Iowa Department of Transportation
 Highway Division
 STANDARD DESIGN - 40' ROADWAY, THREE SPAN BRIDGE
PRETENSIONED PRESTRESSED CONCRETE BEAM BRIDGES
 AUGUST, 2009

PIER BEARING DETAILS H40-44-06

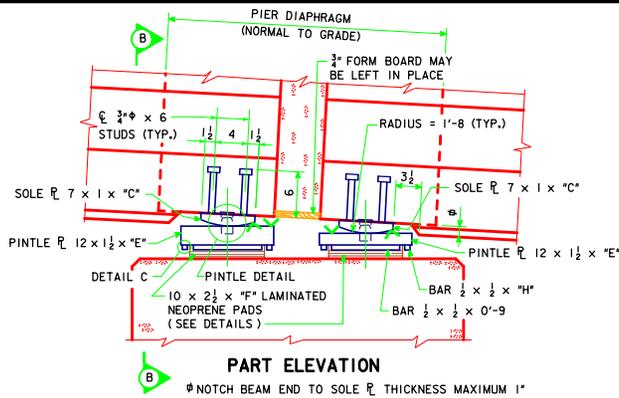
CORRECTION 06-11 - THE REFERENCE TO BAR DIMENSION "A" WAS CHANGED TO "H" IN SECTION B-B FOR A & B BEAMS.
